## CHRYSLER A604 (41TE) UPDATE HANDBOOK

### "UPDATE HANDBOOK"

Since the introduction of the Chrysler A604 (41TE) transaxle in model year 1989, there have been many engineering changes to greatly improve pleaseability, durability and driveability concerns. These changes have affected nearly every part used in the A604 (41TE) transaxle. This "Update Handbook" will explain each change, the reason for the change, any interchangeability concerns created by the change and any part numbers necessary to "Update" your unit. This booklet has been designed to be used in conjunction with the assembly and disassembly manual, also available from ATSG.

Figure 66

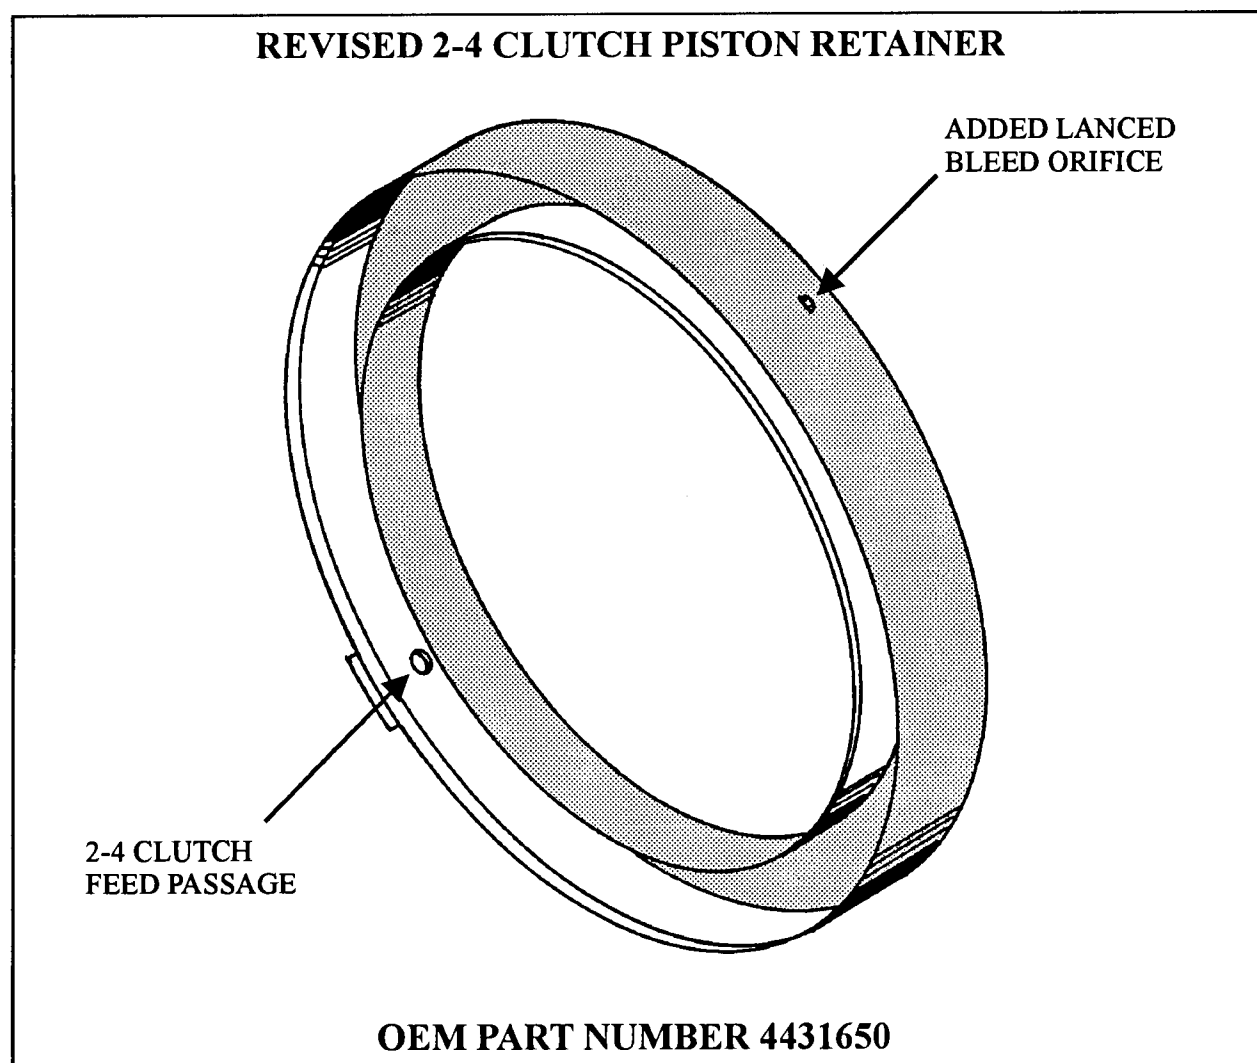
**CHANGE:** Beginning at the start of production for the 1995 model year, all Chrysler A604 (41TE) and A606 (42LE) transaxles were produced using a revised 2-4 Clutch Piston Retainer with an added lanced bleed orifice (See Figure 66).

- (1) 2-4 CLUTCH PISTON RETAINER - Lanced bleed orifice added to the retainer in the location shown in Figure 66.

The revised 2-4 Clutch Piston Retainer with the added lanced bleed orifice will back service ALL previous models of Chrysler A606 (41TE) and A606 (42LE) transaxles. There was not a part number change, so the revised retainer is available under OEM part number 4431650.

Figure 73

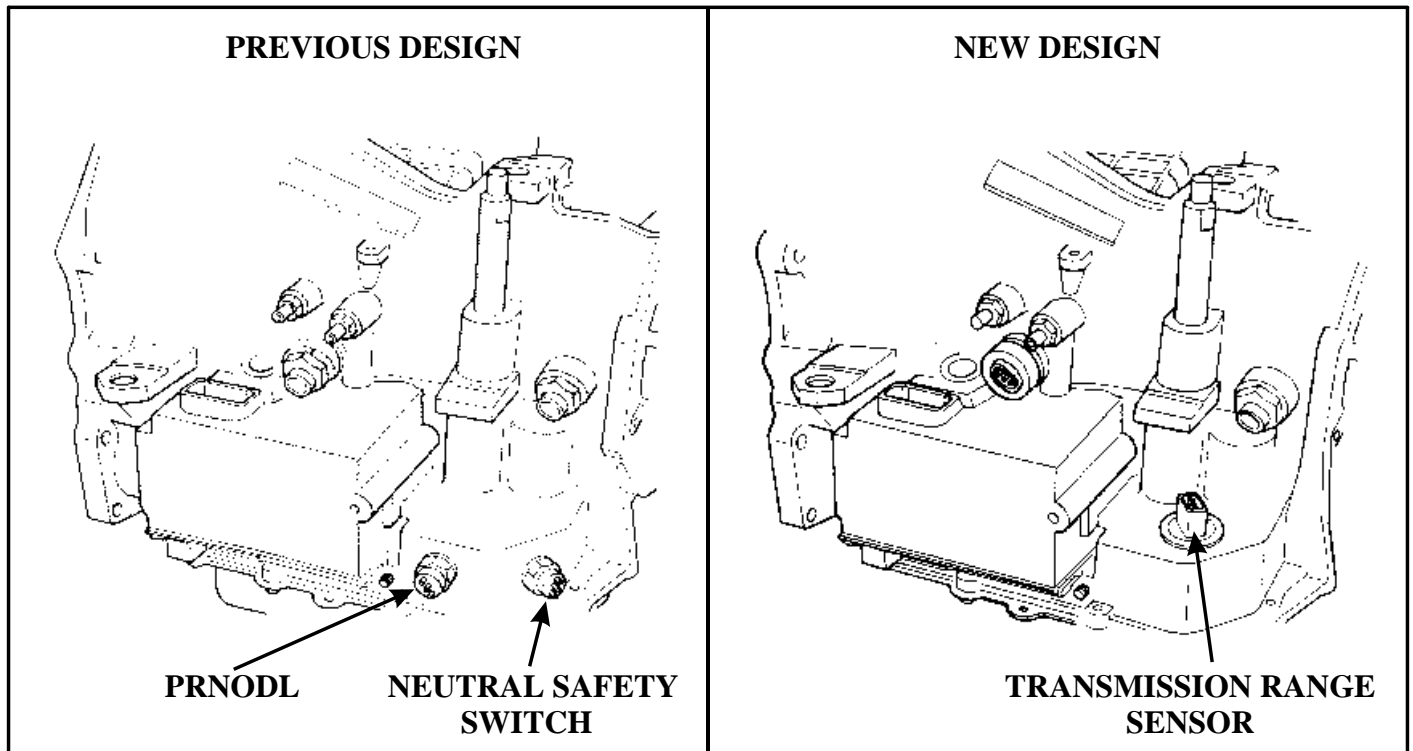
**CHANGE:** Beginning at the start of production 1996, some models equipped with the 41TE (A604) transaxle replaced the PRNODL and Neutral Safety Switch with a Transmission Range Sensor as seen in Figure 73.

- (1) PRNODL SWITCH - The previously used Park, Reverse, Neutral, Overdrive, Drive, Low Switch (PRNODL) has been eliminated and replaced with the new Transmission Range Sensor (See Figure 73).

- (2) NEUTRAL SWITCH - The previously used Neutral Switch has been eliminated and replaced with the new Transmission Range Sensor (See Figure 73).
- (3) TRANSAXLE CASE - The casting of the case change with the elimination of the two threaded holes for the PRNODL and Neutral Safety Switch. An access hole has been added to accommodate the new TRS sensor connector as the switch which is mounted on the valve body (See Figure 73).

Figure 74

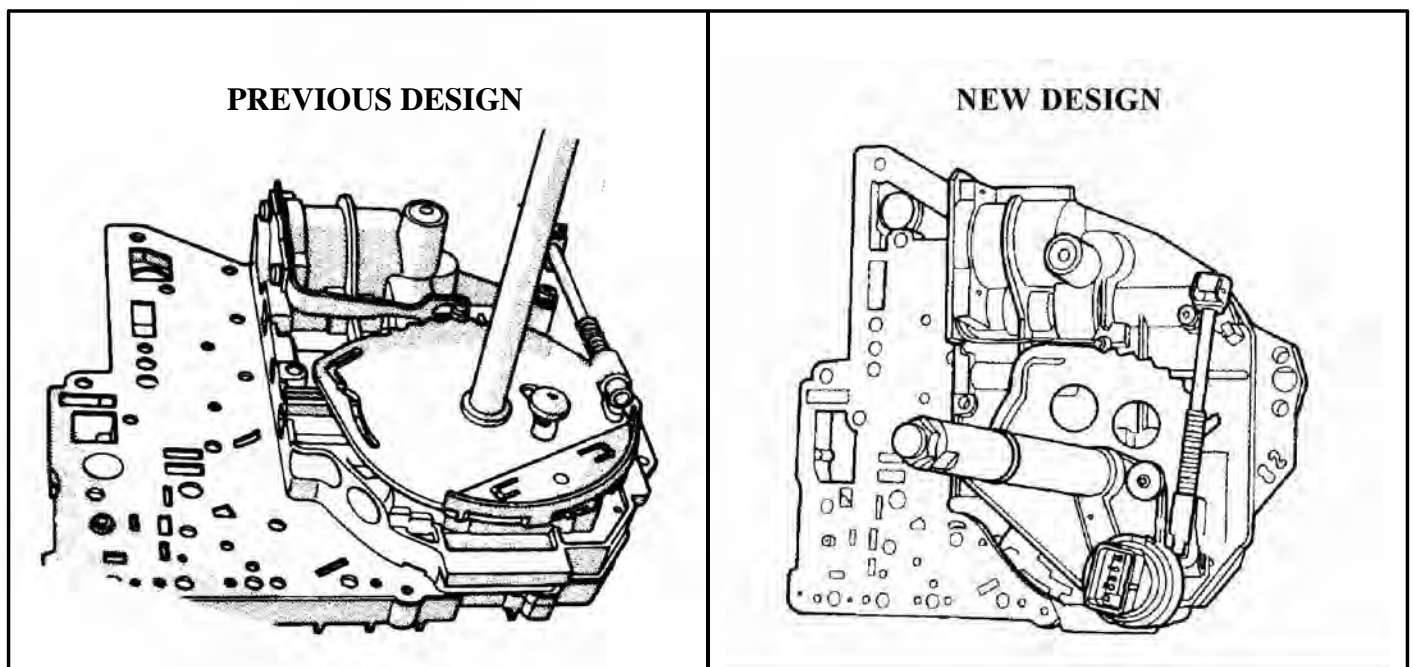
- (4) VALVE BODY - The manual arm shaft and rooster comb assembly and the valve body changed in design to accommodate the mounting of the new TRS sensor (See Figure 74).
